<b>XtremeAir GmbH, Harzstr.2, D-39444 Hecklingen</b> Tel: +49 39267 60999 0, Fax: +49 39267 60999 20 www.xtremeair.de info@xtremeair.de	Document No. <b>SB-2014-004</b>
		Issue: A.01
DOA-Nr.: EASA.21J.360	<b>Service Bulletin SB-2014-004</b>	Date: 21.07.2014

Subject: Wing tank fuel vent

Aircraft type affected: XA41-XA42

Figure 1: Vent line possible vertical movement to near horizontal position against the wing spar. (View on the inside of LH wing tank).

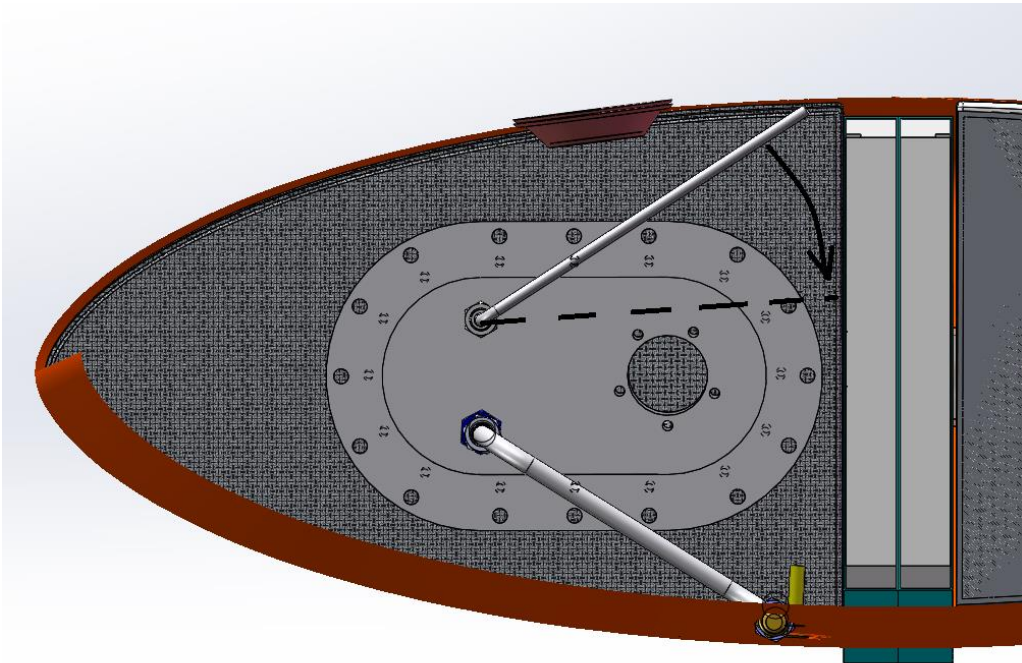
Background: The wing tank vent lines have a possibility of being obstructed against the wing spar due to production tolerances. This can be a problem during long cross-country flights where the fuel selector is not operated according to the AFM chapter 4.8 (switched between the LH and the RH wing tank each 30 minutes). The reliability of the fuel vent line system is improved by performing this service bulletin.

1. Empty the wing tank.
2. Remove the wing tank filler cap and identify through the opening the fuel vent tube on the tank plate.
3. Check the vertical movement of the vent tube. Check if it is possible for the tube to move to a nearly horizontal position

against the wing spar by which the fuel vent could get obstructed. (See Figure 1).

4. In case it could be obstructed, continue performing this service bulletin.
